RECEIPT DATE: 4/25/14 **ONSITE SEWAGE DISPOSAL SYSTEM**

PROPERTY ADDRESS: 15280 Sweetbay Street

Reference: Belle Haven Estates, Lot 25
15280 Sweetbay Street
BAT Site Plan
DDC Project No.: 06116.5

SITE PLAN FOR BAT INSTALLATION

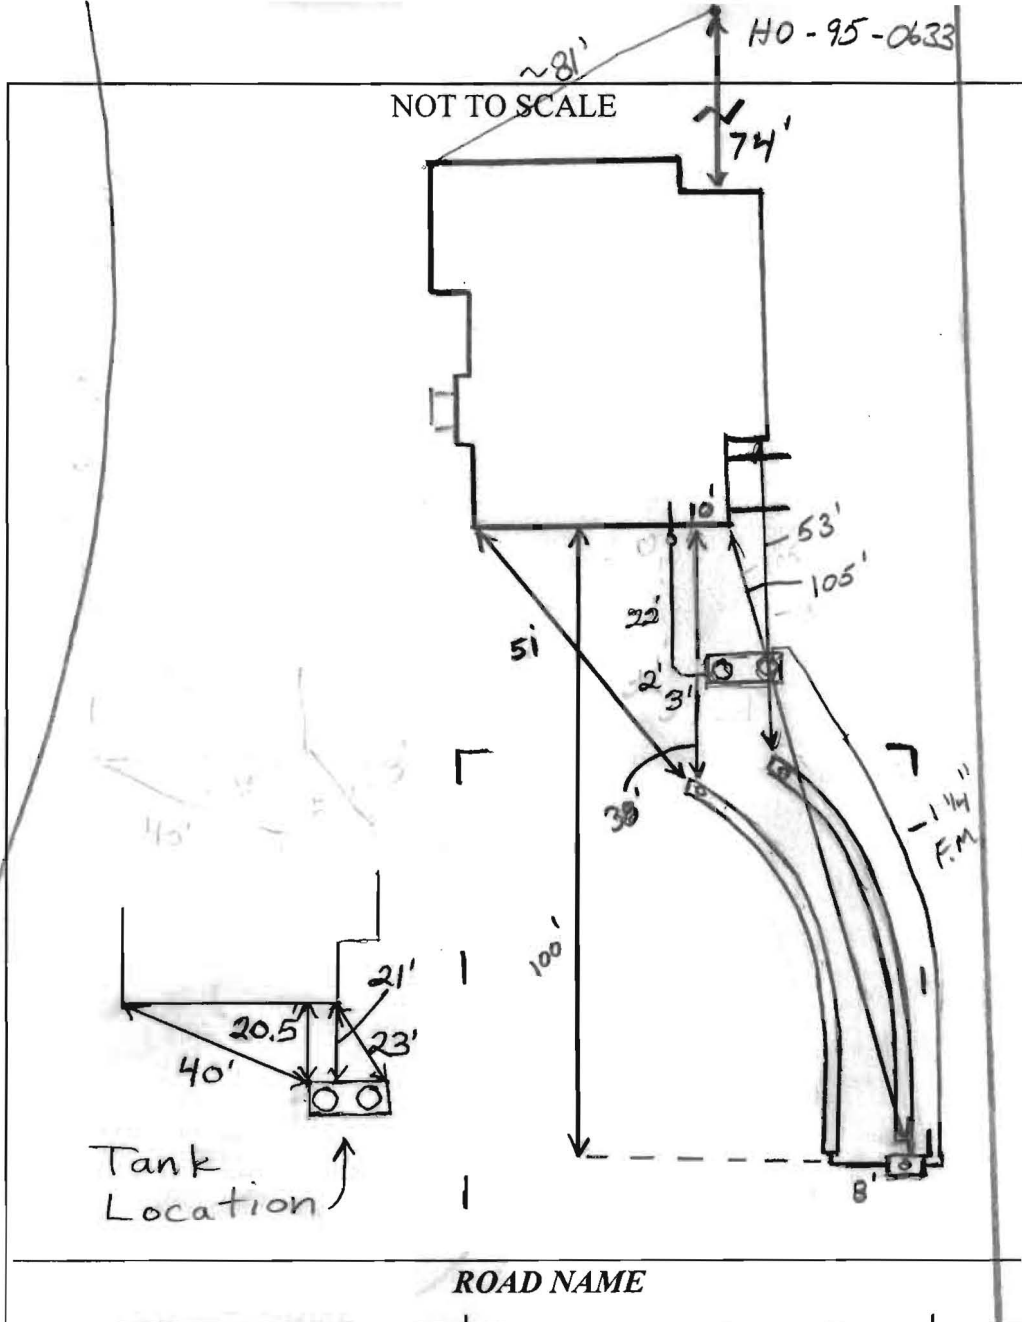
7/30/14 Set BAT unit per surveyed staked location matching BAT site plan. Trench spec's adjusted for 'Deep' trench system. Use 2' wide trenches. Install 2 x 65' trenches inlet 4' below grade bottom @ 0'. Stone amount will remain the same. Call for inspection. (K.W.)

8/6/14 No tank set. Trenches installed per layout. Contractor added 1 foot of stone to inlet. Stone used in tanks looked okay. Trenches already complete. Told contractor need to see stone before it goes into trenches OK to pour tanks (K.W.)

8/7/2014 System finished except for pump and alarm test. Need certification from HOOT representative. (CB)

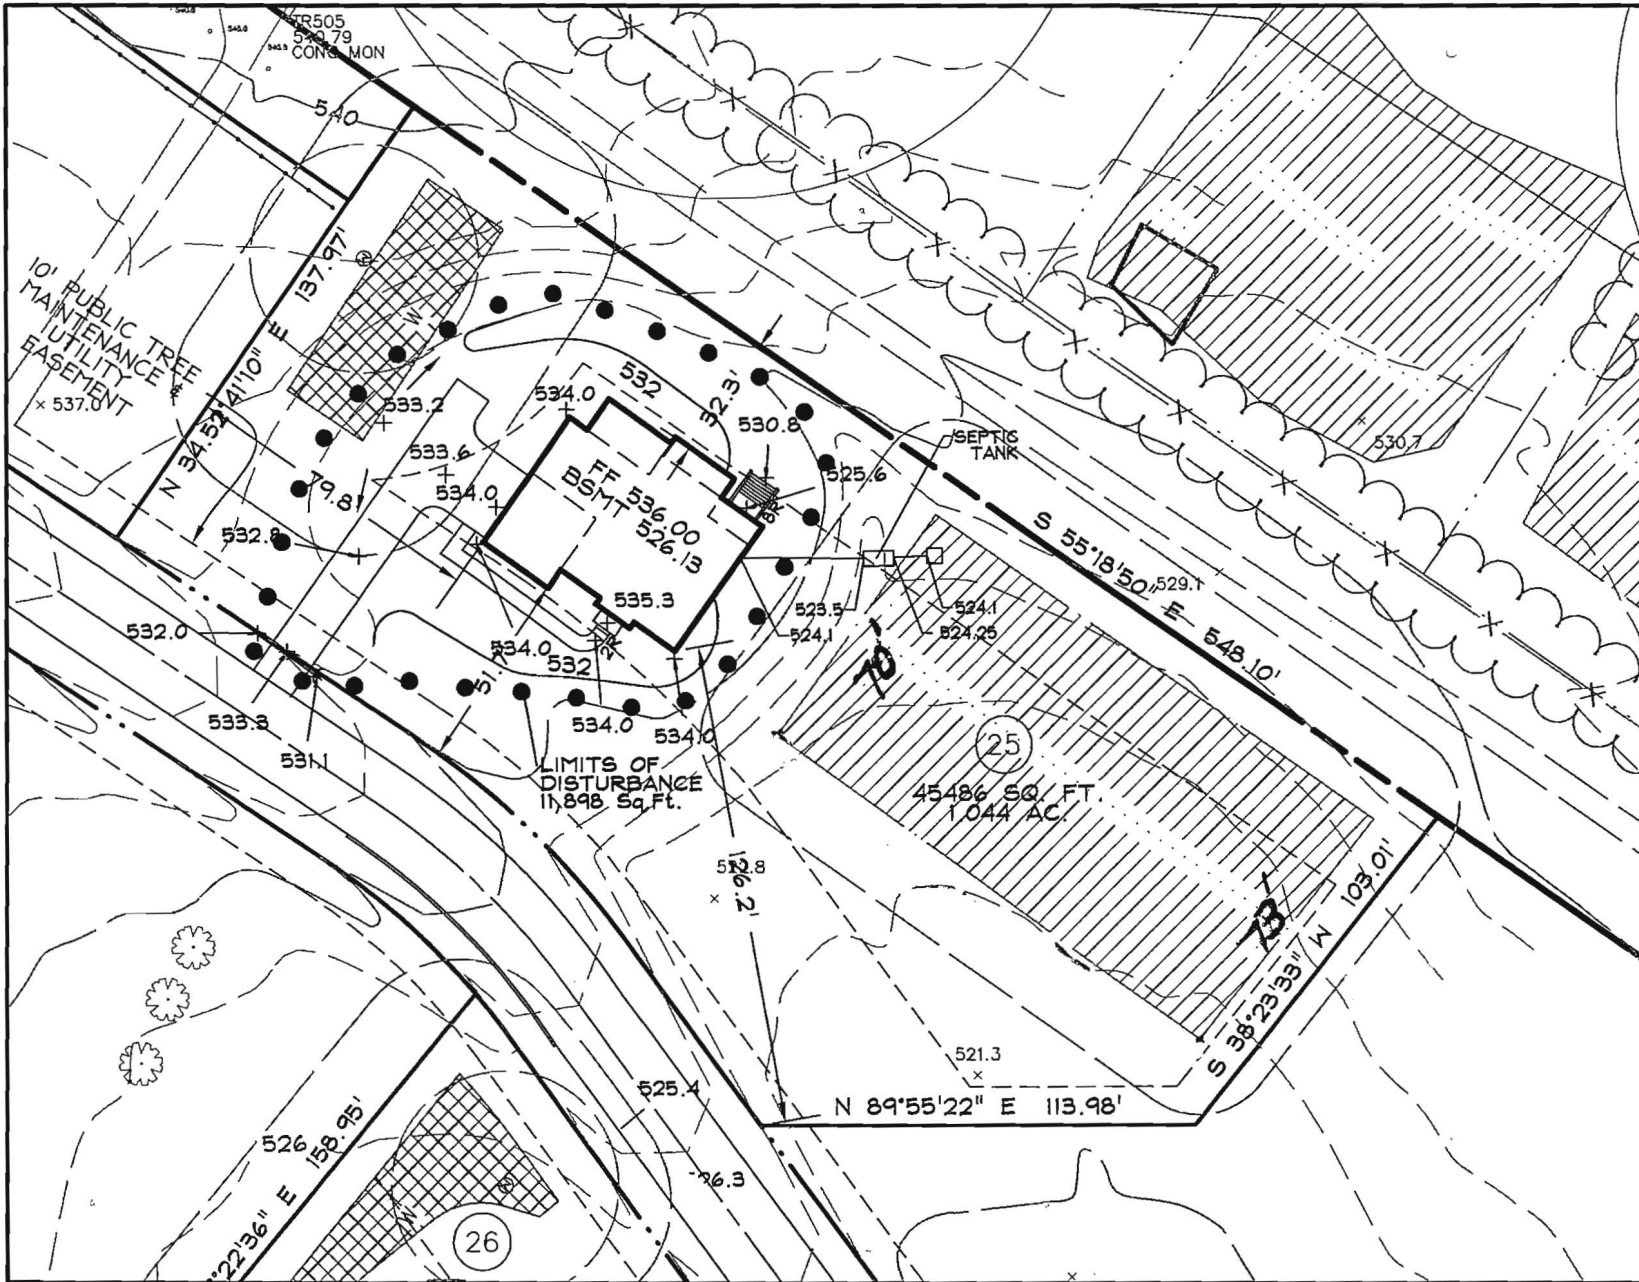
Comment: Compare "to drain field inv 523.7" with "522.7" invert elevation in specs.

Response: The invert elevation in the profile was separated from the "to drain field" label to eliminate confusion.

SEPTIC SYSTEM PROFILE

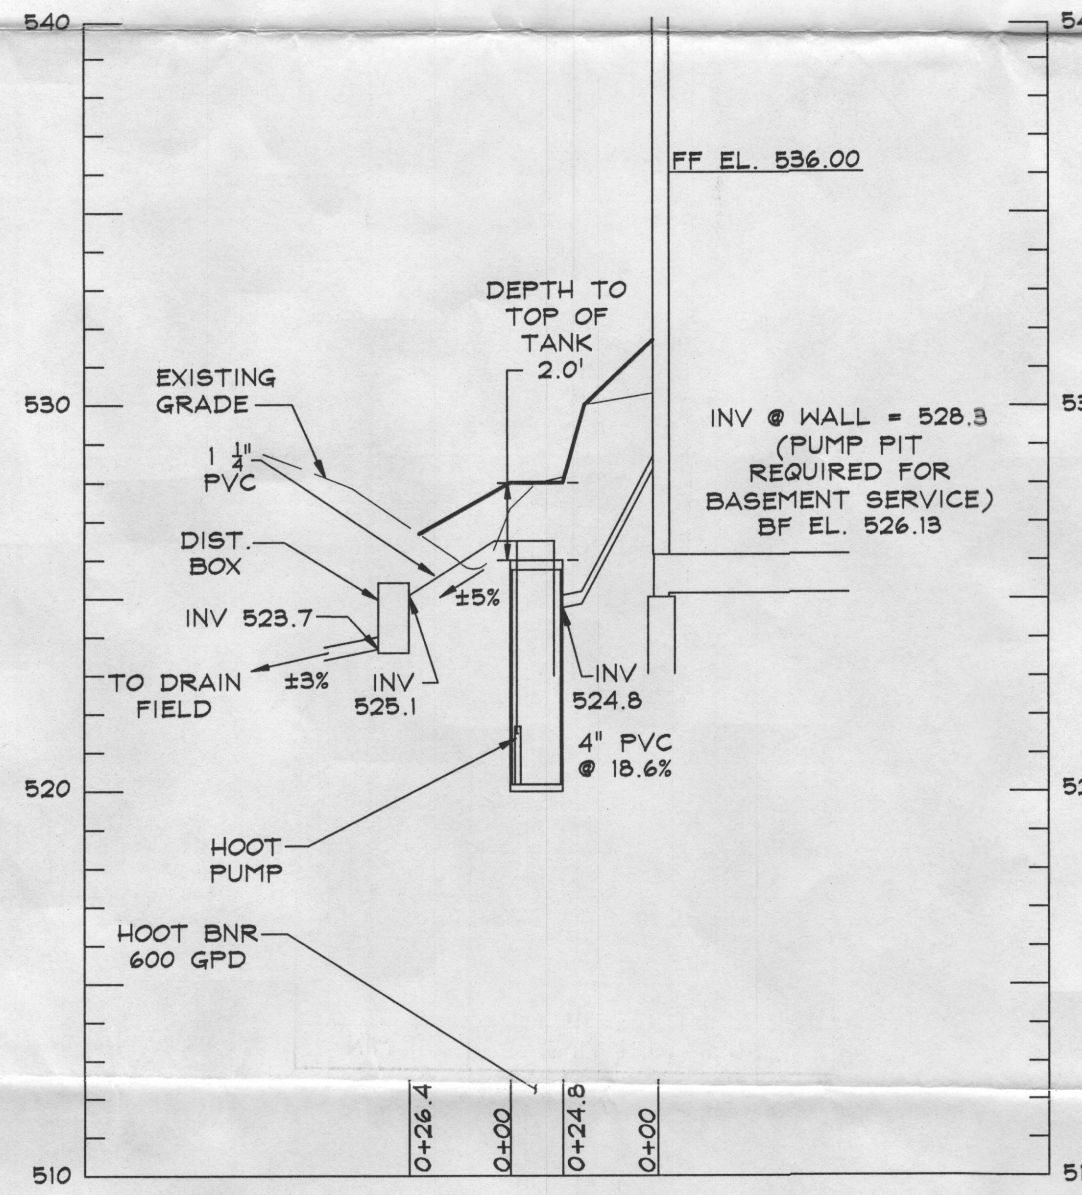
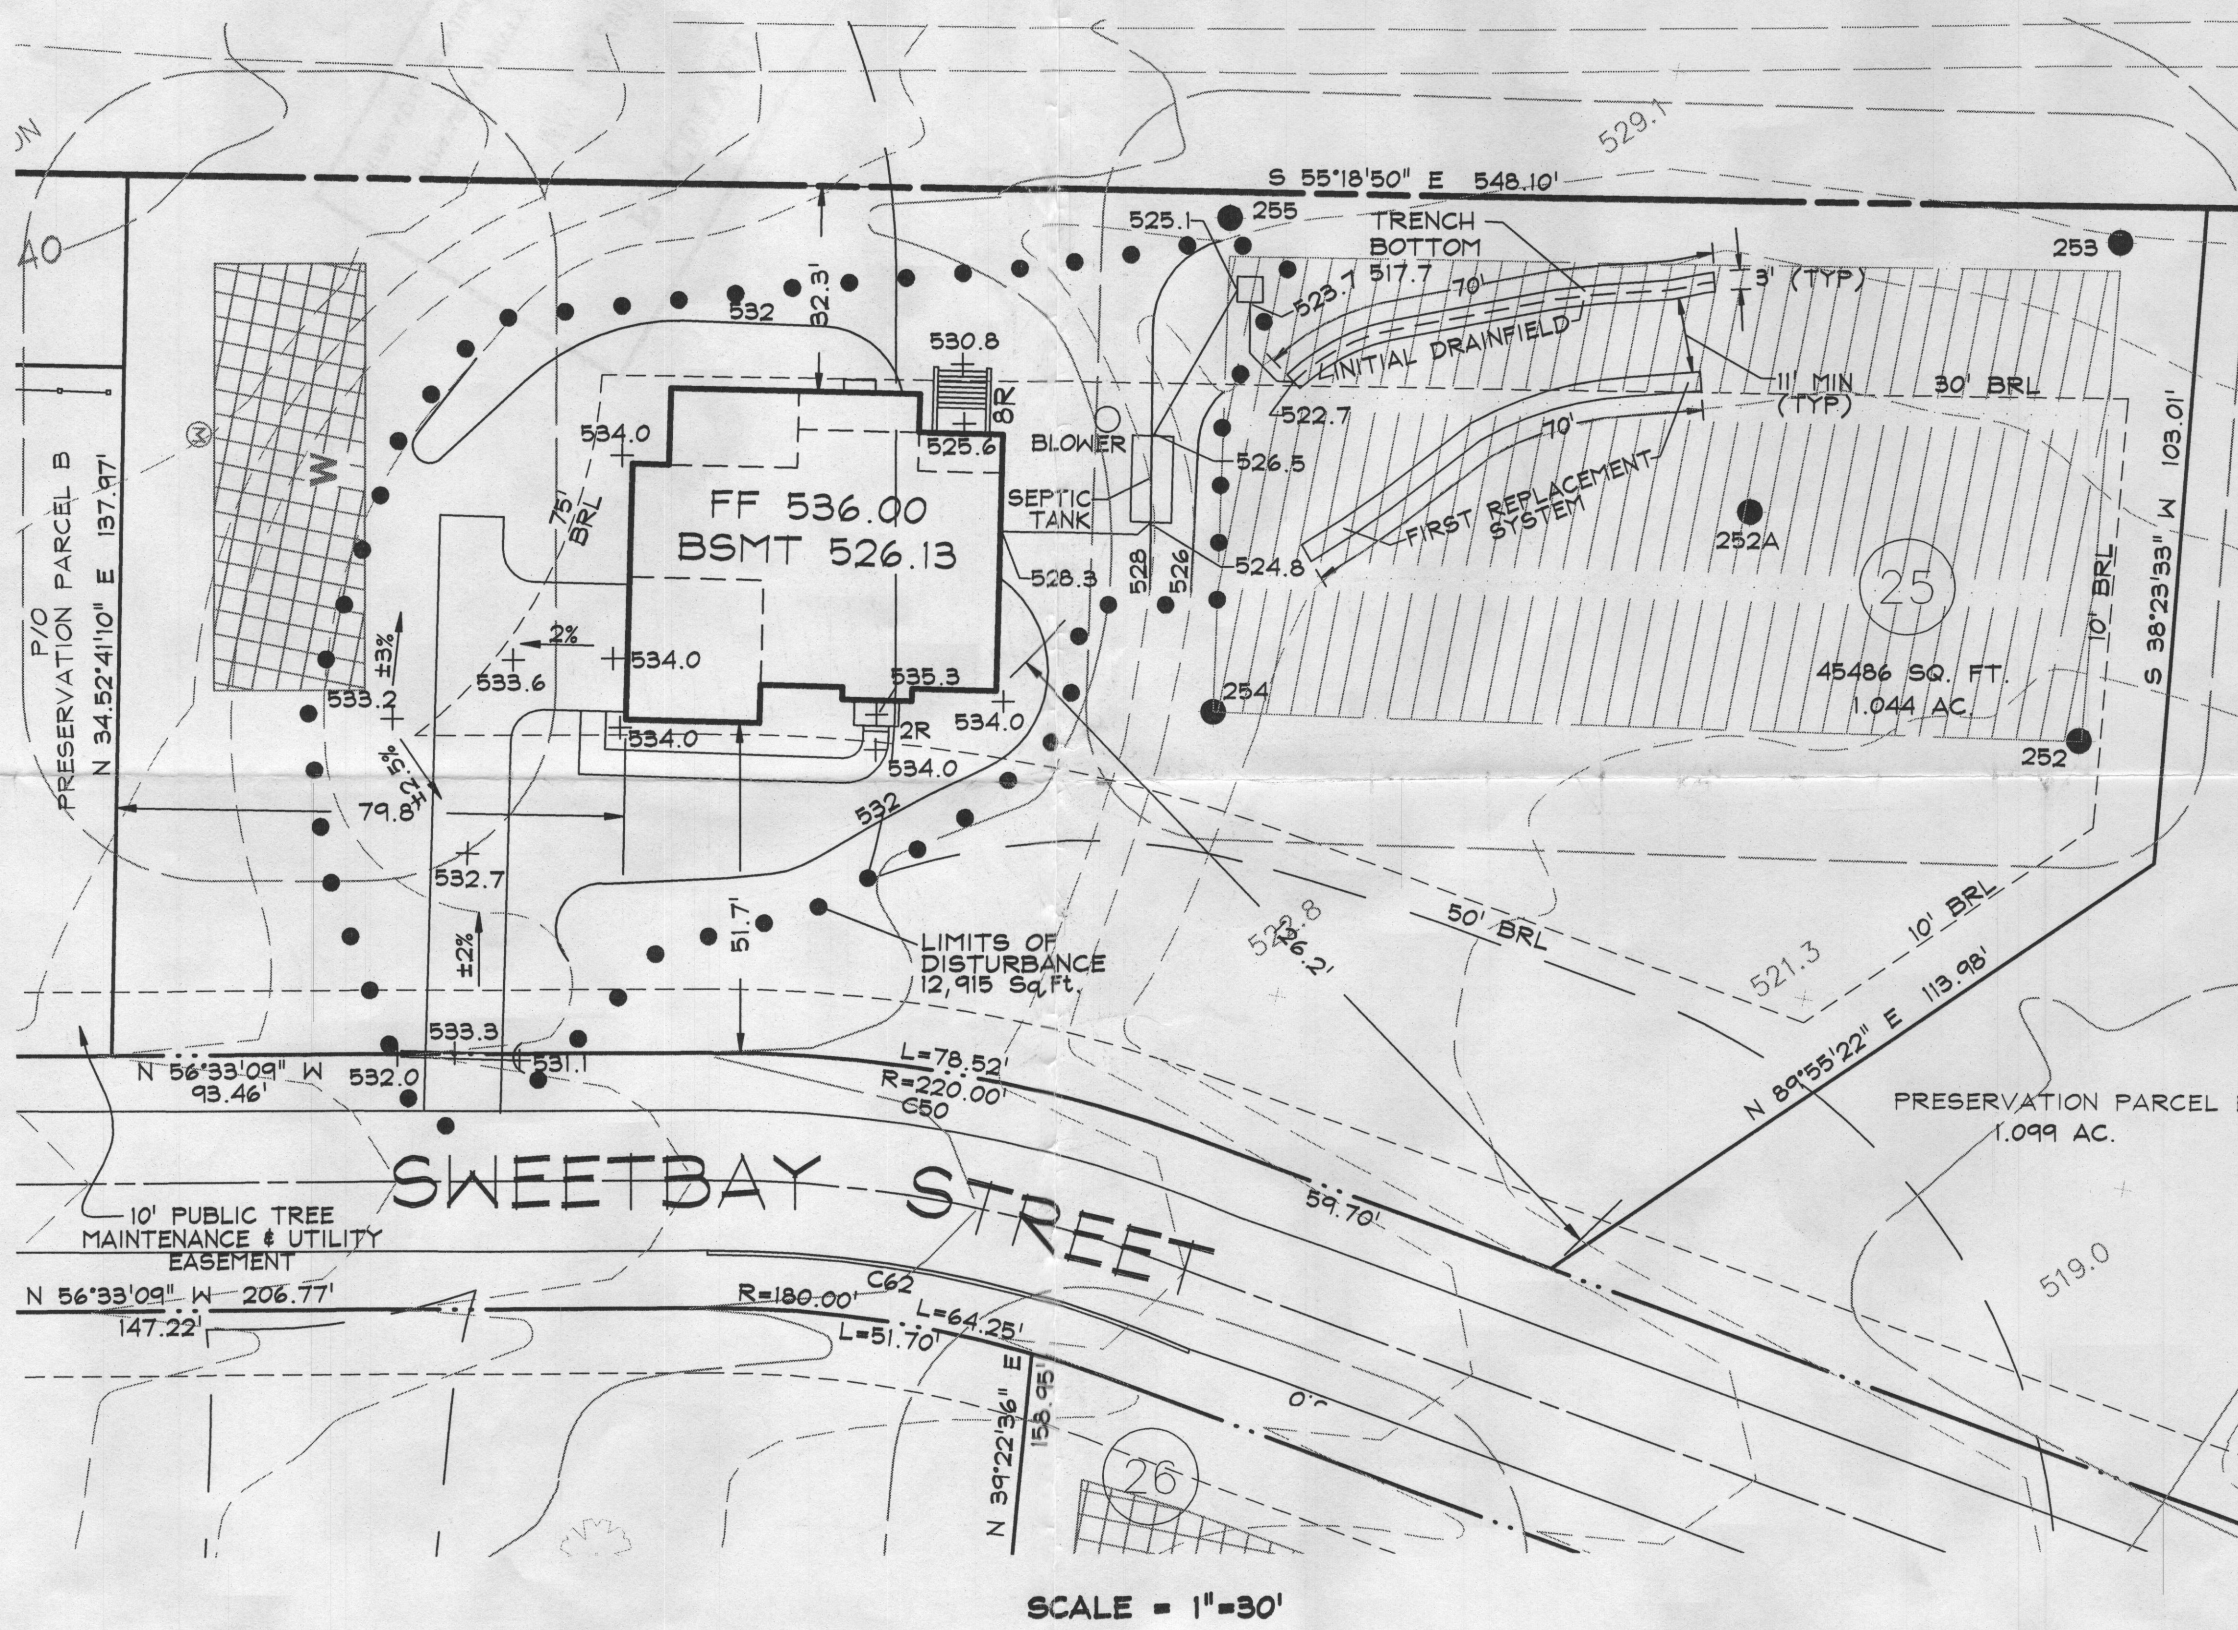
Comment: Piping slope % from tank to D-box

Comment: Fill Depth over D-box

Response: Pipe slope from the tank to the D-box and from D-box to the drain field has been added to the profile.

Response: The existing grade in the profile has been labeled to clearly delineate the depth of fill over the D-Box
